# Access Compliance Report

### (Curb Ramps)

Intersection ID: 48826	Main Street: DISCOVERY_LN	Cross Street: PLEASANT_GROVE_RD	Location: E
ADA ID: 2366C02323CA	Ramp Type: Perp	Initial Pass/Fail: Fail	Overall Compliance: No
Severity Score: 21.25			
Codes/Mitigation Info/Possible Solution		Field Measurements/Component Compliance

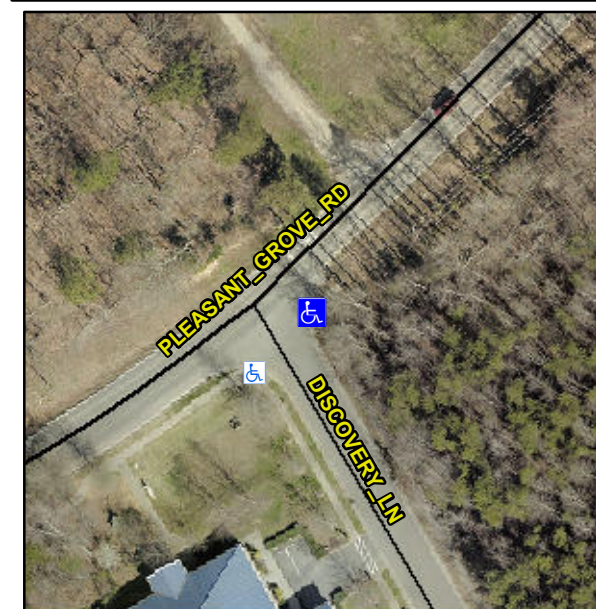
**Not Found, R304.5.1, R304.2.2**

Compliance	Description	Data	Compliance	Description	Data
N/A	Ramp Length (in)	60.0	No	Ramp Slope (%)	8.4
No	Ramp Width (in)	47.0	Yes	Ramp XSlope (%)	0.5
N/A	Flare Type LT	N/A	N/A	Flare Type RT	N/A
N/A	Flare Slope LT (%)	N/A	N/A	Flare Slope RT (%)	N/A
N/A	Flare Traversable LT?	N/A	N/A	Flare Traversable RT?	N/A
N/A	Landing Length (in)	N/A	N/A	DWS Provided?	N/A
N/A	Landing Width (in)	N/A	N/A	DWS Contrast?	N/A
N/A	Landing Slope (%)	N/A	N/A	DWS Length (in)	N/A
N/A	Landing X Slope (%)	N/A	N/A	DWS Full Width?	N/A
N/A	Landing Curb? (Y/N)	N/A	N/A	DWS Offset (in)	N/A
N/A	Shared Landing?	N/A			
N/A	Gutter Ponding?	Yes	N/A	Gutter Slope (%)	N/A
N/A	Gutter Lip Ht (in)	N/A	N/A	Gutter X Slope (%)	N/A
N/A	Painted X Walk1?	No	N/A	Painted X Walk2?	N/A
	X Walk 1 Direction	To SW		X Walk 2 Direction	N/A
N/A	X Walk 1 Width (in)	N/A	N/A	X Walk 2 Width (in)	N/A
	X Walk 1 Slope (%)	2.3		X Walk 2 Slope (%)	N/A
	X Walk 1 X Slope (%)	0.6		X Walk 2 X Slope (%)	N/A

**Remove & Replace Entire Ramp.**
